Purpose of Change—base unit

Re: Application for a Permissive Change Filing with FCC ID: EW780-0835-00.

The purpose of this document is to describe all the changes that are made on **BASE Unit** to the re-skin family models **DL72219** from the original model **RT802** in order to meet the requirements.

Original DECT ANT	New DECT ANT

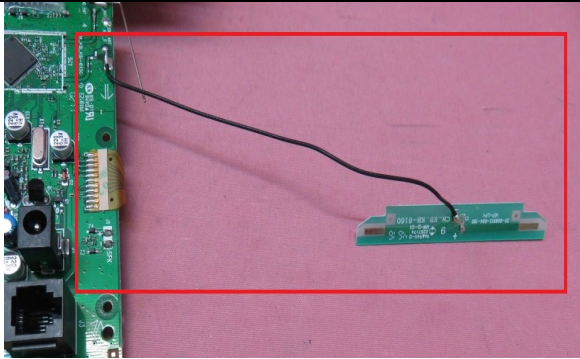
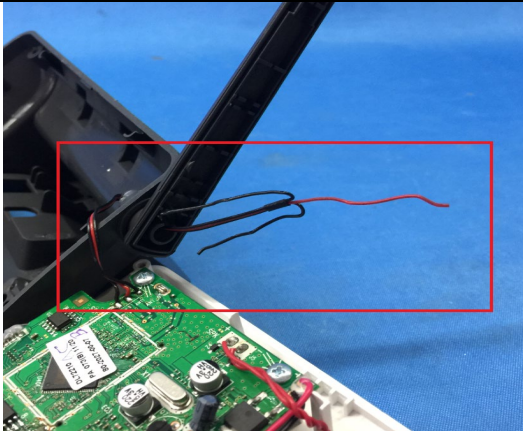
- External appearance is the different
- DECT Mic is removed
- Adaptor change to A318 -060040W-US1 Ao Hai, Tenpao and VTPL
- DECT RF matching circuit is different
- Flash is changed from 25Q32JVSIQ to 25Q64FWSIG
- Shield can for RF module was removed
- Base keyboard is different
- DECT Antenna 1 was changed and Antenna gain changed from 0dBi to 2dBi
- Bluetooth Antenna was changed

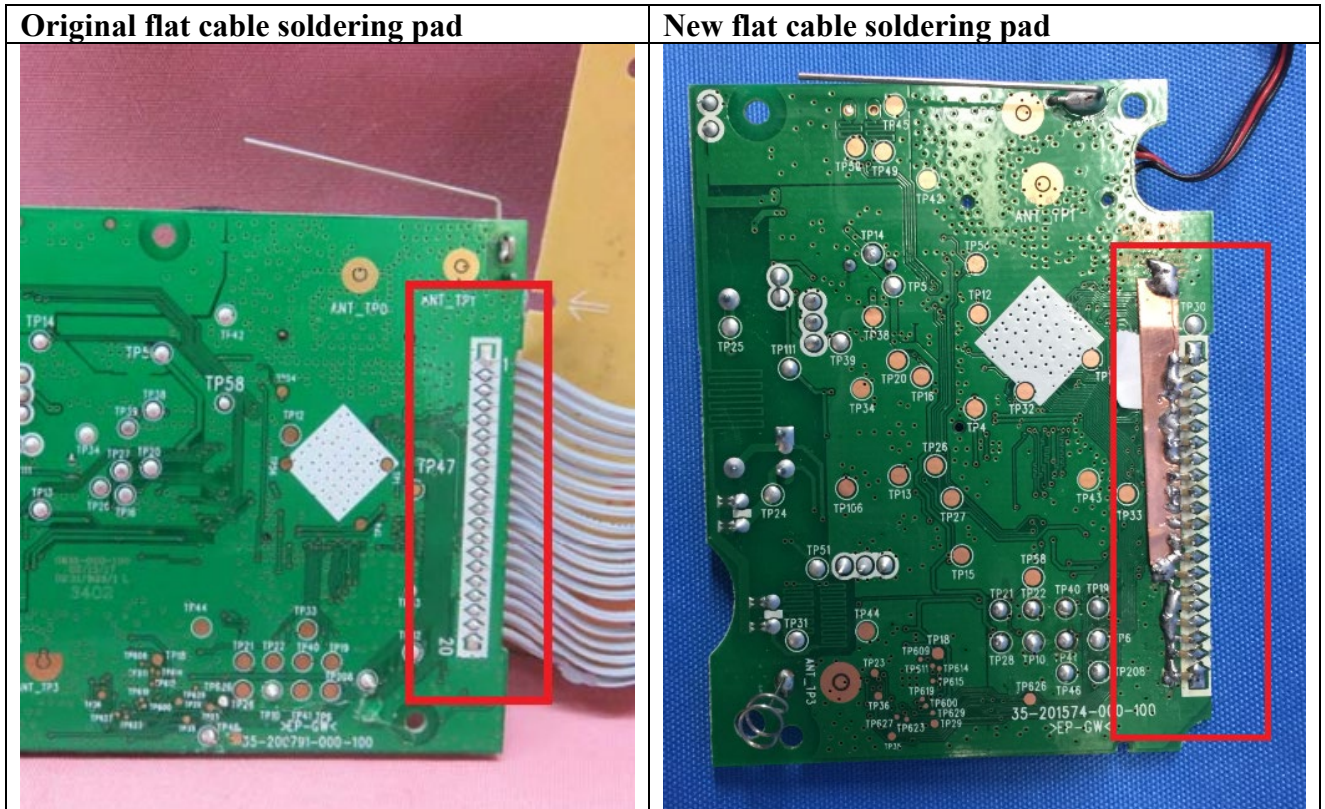
- New flat cable soldering pad, each pins to added with 100pF capacitance to ground to improve EMC.
